SUMMARY OF SUBMISSIONS
Multiple Properties, Adonis Street / Cockram Street / Richardson Street Mundijong
Local Structure Plan - Mundijong F6 - PA24/754
Advertising Date: 5 December 2024 – 24 January 2025

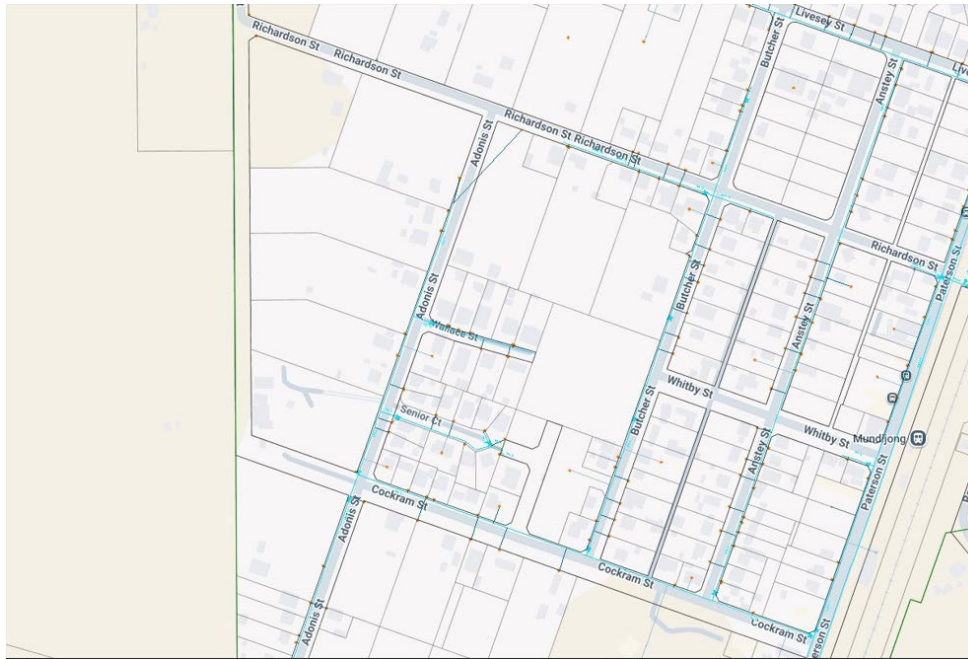
Submitter	No	Submitter Comments	Officer Comment	Applicant Comment
		<p>within the Corporation's 5-year Capital Investment Program. The Corporation is currently liaising with one of the land developers in the structure plan regarding the detailed scoping and delivery of the pump station.</p> <p>The subject area also requires a DN450 gravity sewer as well as a DN300 gravity sewer which are not part of the scope of works for Scott Rd Interim Wastewater Pump Station. These gravity sewer pipes are currently out of the Water Corporation's 5-year Capital Investment Program. Attached is an excerpt of the wastewater planning which shows these sewers.</p> <p>Drainage</p> <p>The subject area falls within the Mundijong Drainage District, a rural drainage system. Developments within this catchment are required to contain the flows from a must be compensated to pre-development levels. The developer of this land should be advised to liaise with Water Corporation at the preliminary planning stage to determine detailed planning requirements as this area could be prone to future flooding. At the time of development (if type of development is known specify) the developer may be required to provide calculations from a consulting engineer to demonstrate, to our satisfaction that the runoff from the development has been restricted to predevelopment levels. To determine the flood level the developer should contact the Department of Water and Environmental Regulations regarding the Drainage and Water Management Plan which includes the subject area.</p> <p>Rural drains are not designed to always give flood protection and some inundation of land can be expected. Water Corporation maintains its existing drains to ensure they are capable of clearing water from adjacent</p>		<p>other option is to work collectively with the adjoining developers to extend the main sewer up to the site. This also needs the wastewater pump station in Scott Road to be constructed.</p> <p>The servicing report provides drainage storage volumes for the 1 year and 1% AEP event basins. Modifications made at the subdivision stage can incorporate a earthworks model to provide an offline basin for the overflow of events exceeding the 15mm 1 year. Regarding the storage of the 15mm 1 year event in the bioretention basin this needs some additional discussion as we have an outlet drain at the base of the retention basin and no soakage/infiltration.</p> <p>The servicing report provides a preliminary layout</p>

Submitter	No	Submitter Comments	Officer Comment	Applicant Comment
		<p>rural properties within three days of a storm event, where contours and internal drainage make this physically possible.</p> <p>Developments within this catchment are required to contain the flows from a one in one-hundred-year storm event on site. Discharge to Water Corporation drains must be compensated to pre-development levels. The developer of this land should be advised to liaise with Water Corporation at the preliminary planning stage to determine detailed planning requirements as this area could be prone to future flooding. At the time of development, the developer may be required to provide calculations from a consulting engineer to demonstrate, to the satisfaction of Water Corporation, that the runoff from the development has been restricted to pre development levels. To determine the flood level the developer should contact the Department of Water and Environmental Regulations regarding the Drainage and Water Management Plan which includes the subject area.</p> <p>General Comments</p> <p>The developer is expected to provide all water and sewerage reticulation if required. A contribution for Water, Sewerage and Drainage headworks may also be required. In addition, the developer may be required to fund new works or the upgrading of existing works and protection of all works. Water Corporation may also require land being provided for works.</p> <p>The information provided above is subject to review and may change. If the proposal has not proceeded within the next 12 months, please contact us to confirm that this information is still valid.</p> <p>Please provide the above comments to the landowner, developer and/or their representative.</p>		<p>of the subsoil drainage, nominally 1.2m blow the finished verge levels. Some invert levels can be added to confirm the system drains out to the basins correctly and are above the existing regional groundwater levels.</p> <p>The approach taken in the LWMS is to maintain pre-development hydrological conditions, and this is demonstrated in the LWMS, the civil design concepts and the landscape concepts.</p>
